**TOWN OF NEWBURGH
PLANNING BOARD
REVIEW COMMENTS**

PROJECT: BRITAIN PLAZA
PROJECT NO.: 13-13
PROJECT LOCATION: SECTION 97, BLOCK 3, LOT 1
PROJECT REPRESENTATIVE: LANC & TULLY, PC
REVIEW DATE: 18 AUGUST 2014
MEETING DATE: 21 AUGUST 2014

RE: Britain Plaza – Commercial Site Plan
Tax Parcel: 97 – 3 – 1
Planning Board No.: 2013-13

LIGHTING PLAN

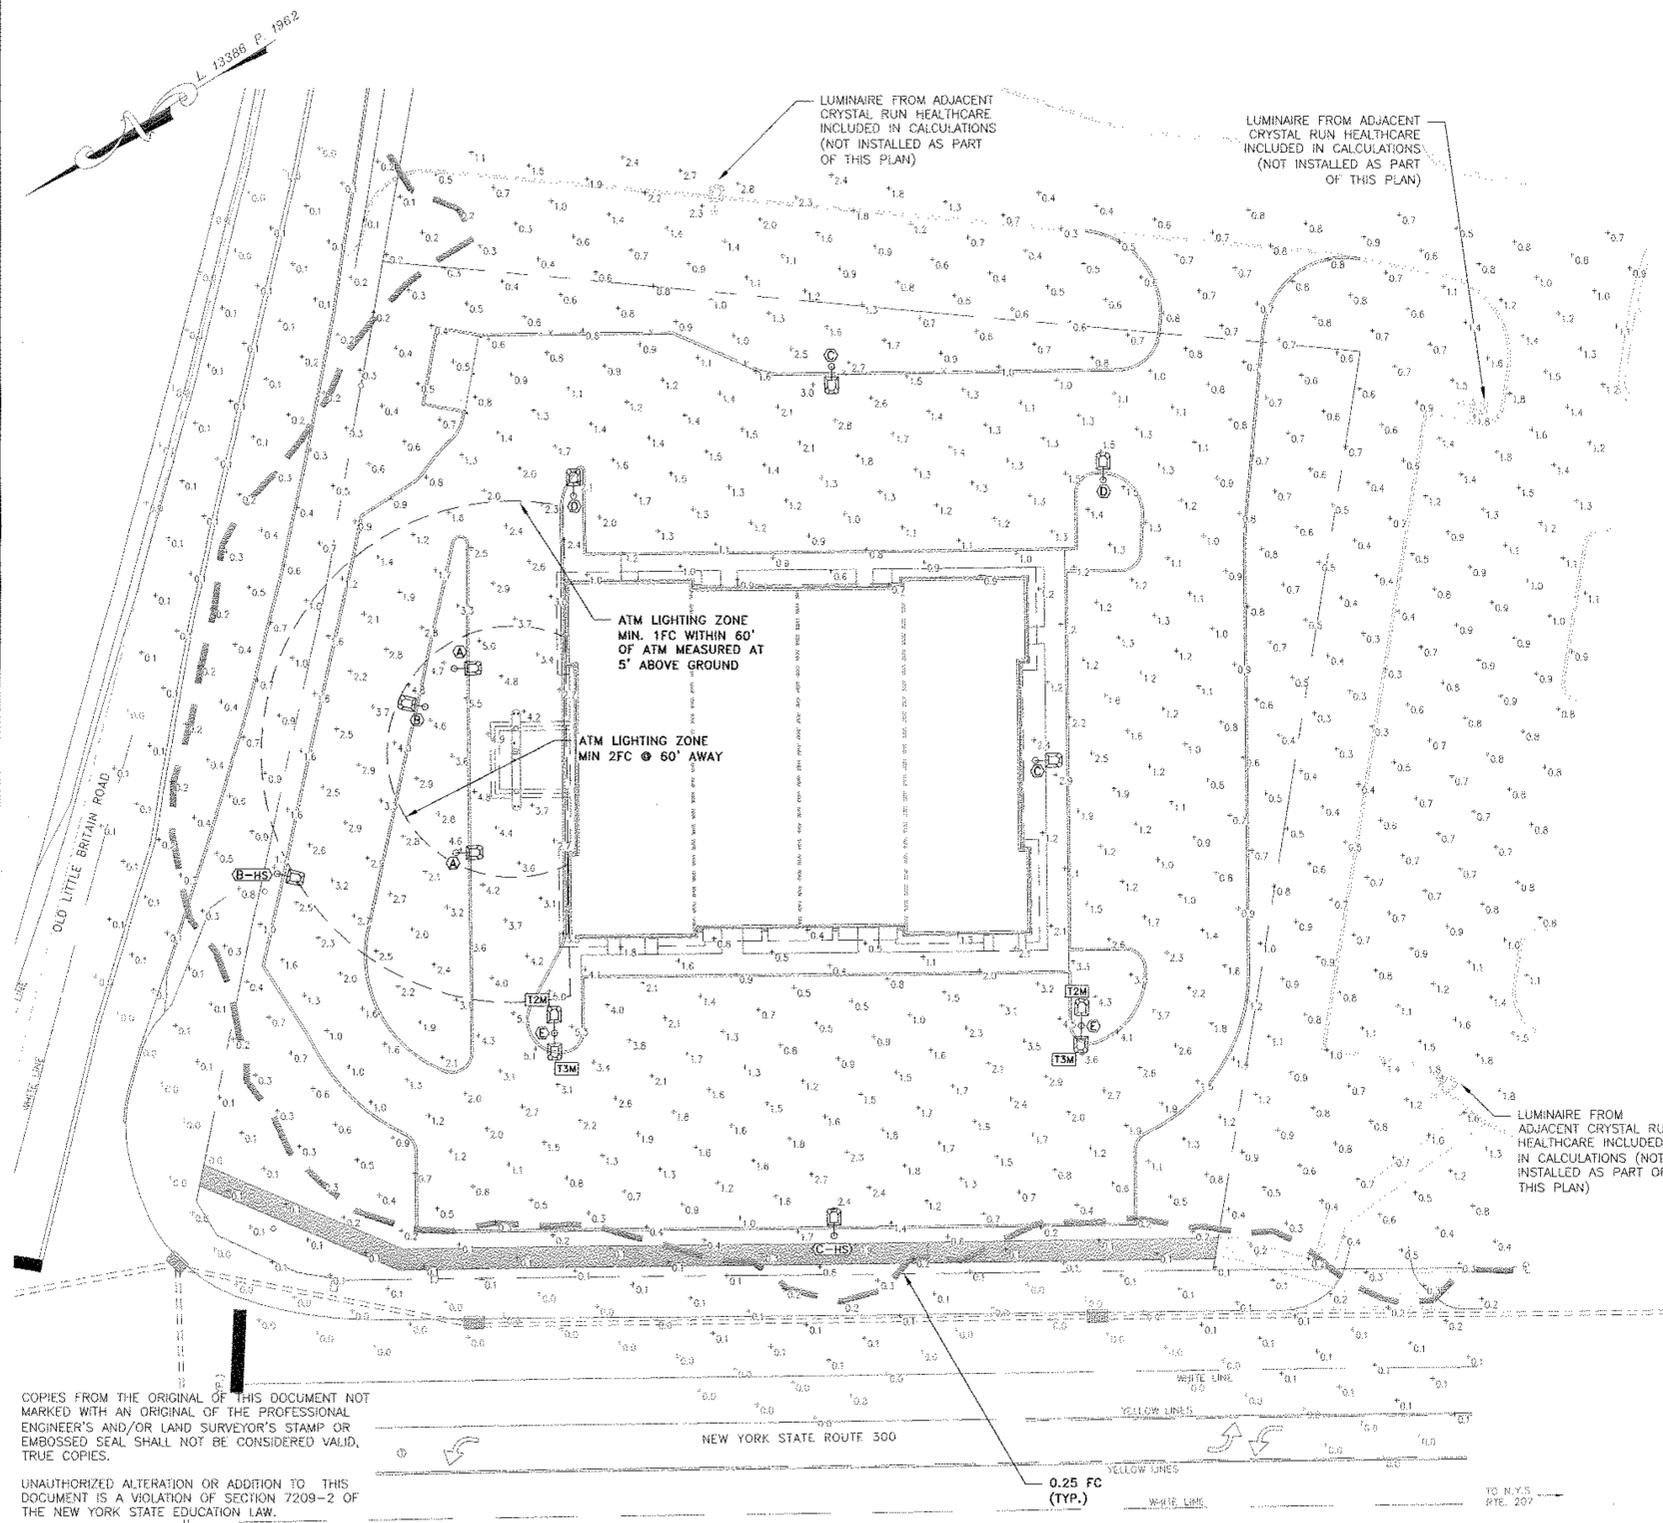
3. The lighting plan has been revised to 16 foot pole heights. Please note that because of the reduced pole heights, additional fixtures have been incorporated.

DUMPSTER ENCLOSURE DETAIL

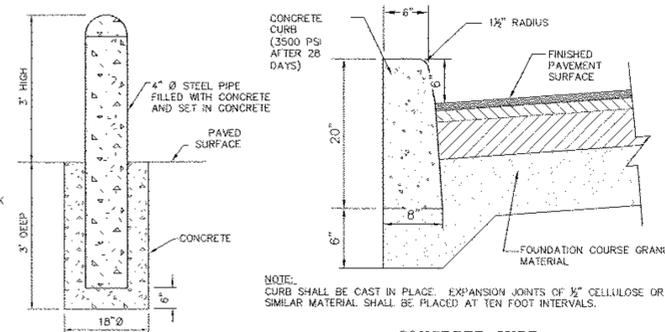
1. As requested, attached is an elevation of the proposed 6 foot high dumpster enclosure with the proposed landscaping screening as prepared by DeGraw and DeHaan Architects. With a focus on building green/ reducing environmental impact, the architects are proposing Kingston Block's Pozzotive CMU (30% replacement of Portland cement with postconsumer recycled material and manufactured locally in Ulster County). The rendering depicts an "Ulster Wheat" split face finish. They have chosen a darker earth tone in order to minimize visual impact and to tie the dumpster enclosure color in with some of the darker earth tones in the stone base. The landscaping plan has also been revised to indicate the larger initial planting sizes for the American Holly (5'-6', B&B) and the Dense Inkberry Holly (3'-3.5', B&B).
